NCC BCA Compliance & Building Condition Audit Report

Project:	Port Hedland Retirement Village
Site Address:	Stevens Street, Port Hedland
Client:	Town of Port Hedland
Our Ref:	P180104
Date:	27 th April 2018
Revision:	1

Figure 2 – Step ramp and landing details for external doorways

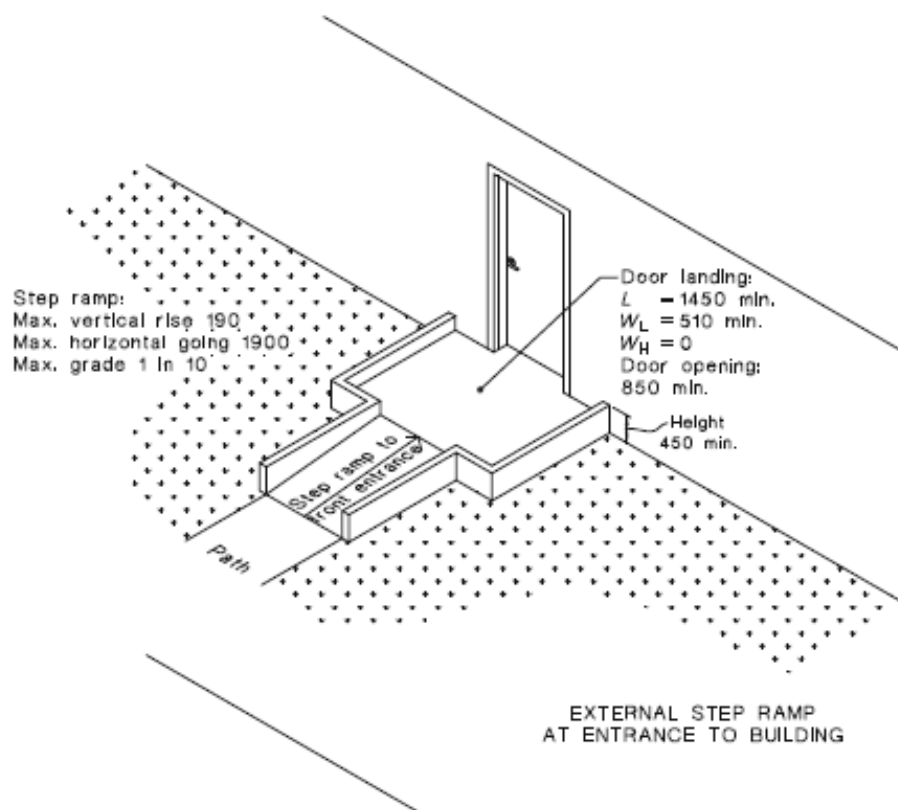
The external doorways all incorporate a step at the threshold of approximately 120 mm down to external paving level. This is a trip hazard and each doorway should be provided with a step ramp as detailed below.

Access would be required to and within the building with step free thresholds to entrance doors. This is not achieved and the ramps provided to entrance doors are too steep and do not provide a level landing or incorporate edge protection. Refer to Figure 1 in this report for details of an adequate step ramp and landing.

Photo 5 – External Walls Vertical Cracks

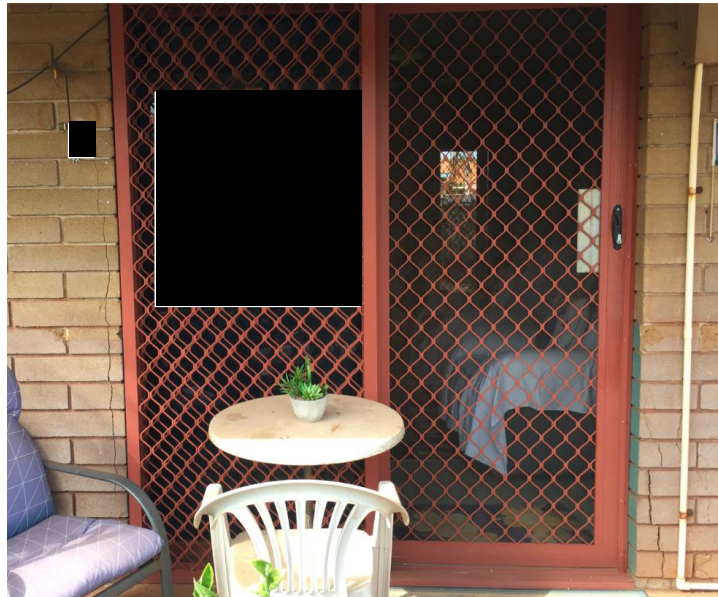
Several buildings have cracking to external walls similar to the above. The cause of these cracks is not clear, and should be investigated by a structural engineer.
